FSK 115 Indian Scout 2015-2016

FSK 115 fits all 2015 bikes but in mid-2016 Indian changed the Top-cap design and size from M37 to M35.

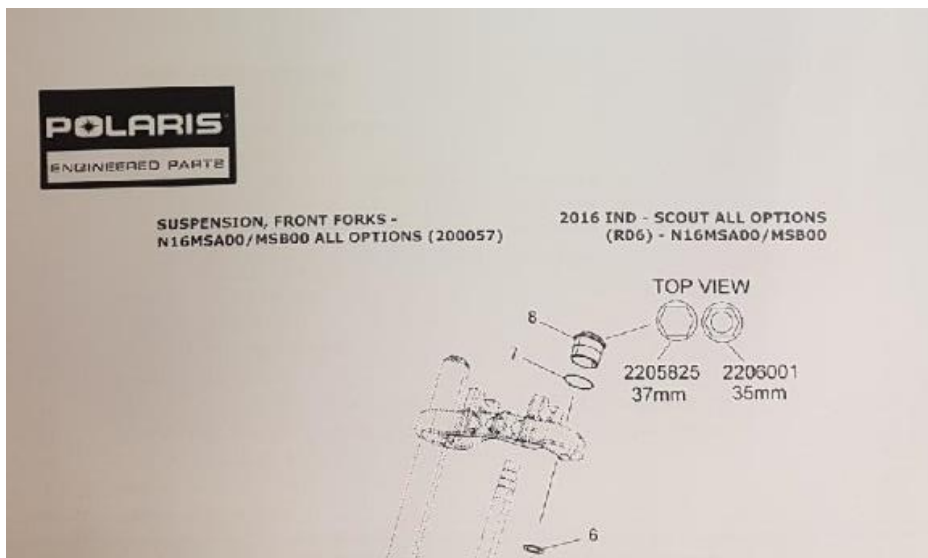
An easy way to recognize if your customer has the M37 which works with the FSK 115 or if they have the M35 which does not work with the FSK 115 is by the following picture we have received from Indian.

For the M35 bikes 2016-2017 we have just released a new kit which will be called FSK 121.

If you have bought cartridge kit FSK 115 from us and wish to convert these to FSK 121 or if you have supplied a customer FSK 115 and they found that it does not fit because they have the 2016 bike with M35 top cap then you are entitled to order from Öhlins DTC a conversion kit called ALDA 338. The ALDA 338 will be supplied from Öhlins DTC free of charge.
